Applicant : Perry R. DeYoung
Appln. No. : 09/586,943
Page : 8

REMARKS

FIG. 1

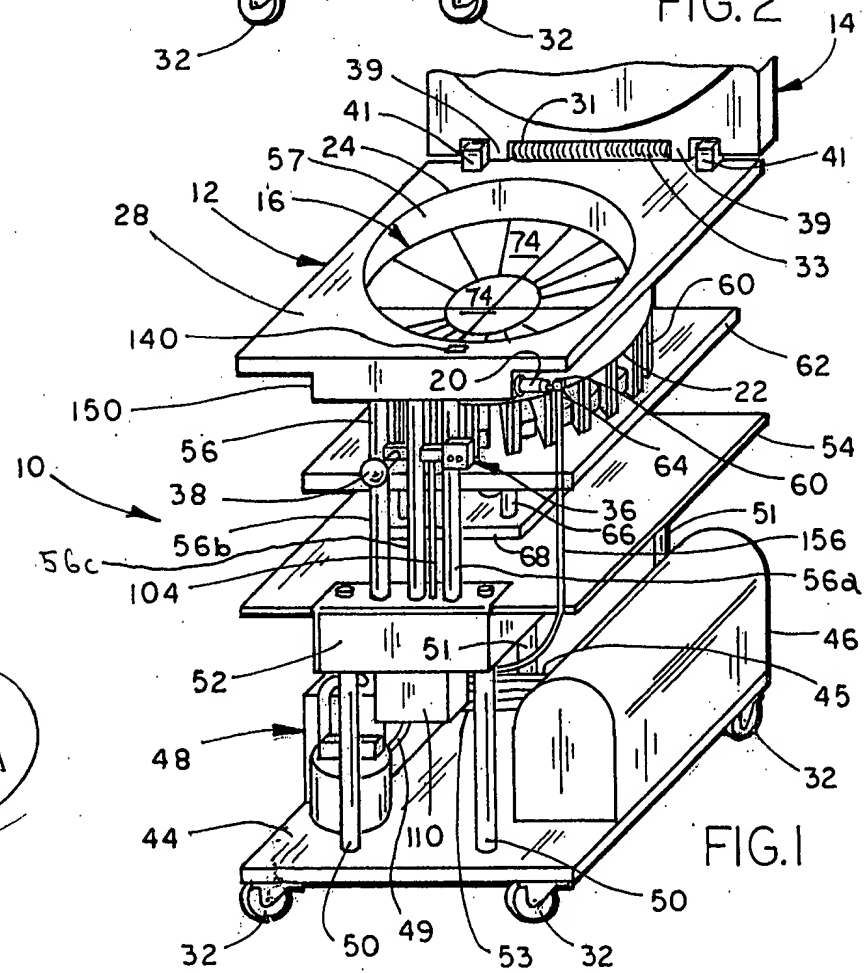
Fig. 1 has been objected to because it is not clear as to whether the center vertically-extending structure between structures 56a and 56b is also a support. The Examiner suggested that numeral 56c along with a lead line should be added to indicate the central support for clarity. Applicant respectfully submits a marked-up copy of Fig. 1 showing the numeral 56c added in red ink for the Examiner's review. Applicant has also added a sentence on page 7 of the specification to refer to the front middle upper support 56c.
